Draft Adelaide Road Footpath and Crossing Master Plan

(These comments were posted using the City of Victor Harbor's Have Your Say comments page, 20 December 2017.)

Tell us what you think about the plan for new footpaths, shared use pathways and crossings around Adelaide Road, Victor Harbor.

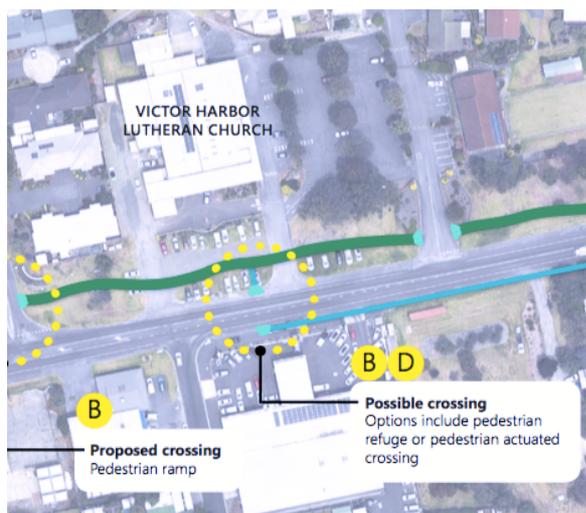
The crossing locations aren't bad as far as they go, however are not entirely adequate to meet the aims of the Footpath and Crossing Master Plan.

- 1) For the roundabout at Hindmarsh Rd/ Port Elliott Rd, pedestrian crossings should be on every leg of the roundabout and these should also be wide enough to accommodate cyclists as well as pedestrians i.e. these should be shared use crossings rather than pedestrian crossings.

- 2) A roundabout is a traffic engineering device that is relatively unsafe for cyclists. Given the high speeds likely at the Hindmarsh Rd/ Port Elliott Rd roundabout, cyclist ramps should be provided at less than 90 degrees to the kerb face to allow cyclists to mount the footpath safely and easily and bypass the roundabout from Port Elliott Rd to Hindmarsh Rd west, Hindmarsh Rd east to Port Elliott Road, and using the shared use path for Hindmarsh Rd west to east. The footpaths should at least be wide enough to accommodate this, and the design preferably feature one-way bike paths adjacent to the actual footpath.

- 3) The new shared use path (SUP) leads to a point opposite the ALDI and onwards route to the Encounter Lutheran College. New kerb ramps are shown, but this location is also likely to attract cyclists off the SUP and should be wide enough to accommodate cyclists as well as pedestrians. Also, there is a large painted median at this point. This should be used to provide a median refuge to protect pedestrians and cyclists crossing here.

- 4) The B/D crossing location is shown at the end of a right turn lane. It is assumed that this lane will be shortened to suit.

- 5) The crossing point marked B/E is too far south for cyclists using Strawberry Hill Road and pedestrians accessing Encounter Lutheran College. The truth is, pedestrians and cyclists will simply not use this crossing point and will instead cross closer to Adelaide Road, whether or not facilities are provided here. We suggest a splitter island in Agnes Gillespie Drive at Adelaide Road, with the

crossing point making use of this. Such a crossing would improve safety even if the island must be designed to be mountable for large vehicles.

It's good to see new footpath development, especially filling in obvious gaps. With cyclists now being allowed to use footpaths, please design footpaths with this in mind. (Though in fact, design should always have respected the safety of children who might use footpaths.) In particular, where new sections of footpath come off the new shared use path, these need to be connected using appropriate, radiused curves, not 90 degree connections. This also benefits people using wheelchairs and mobility scooters ("gophers"). See Austroads [Guide to Road Design Part 6A: Paths for Walking and Cycling](#), for design advice about radii, but a minimum 2m radius should be applied.

There appears to be a footpath gap on Hindmarsh Road, near Alexander St. While there is bitumen here, it is part of the carriageway. It would be good for the designated pedestrian area to at least be line-marked, but better if it could be painted or similar.

It's great to see the shared use path (SUP) proposal, servicing several major land uses. However, as shown, the SUP appears to end in the middle of nowhere. It would be sensible for cyclists to travel onwards via Strawberry Hill Road, using the new footpath outside of the proposed ALDI development; or the local road network to Coromandel Drive. Assuming the future SUP extension is not proposed to occur immediately following these works, it would probably be a better idea to end it at the crossing point shown with a C (i.e. leading to Coromandel Dr) and to construct the new footpath in front of ALDI east of this crossing point as SUP instead.

One note: future driveways for proposed development are not shown. These should be designed as driveways crossing a footpath, not the other way round. That is, pedestrians and cyclists going about their business should have priority over car access to development. This is ensured with continuous footpath design, making it clear that these crossing points are road-related areas.
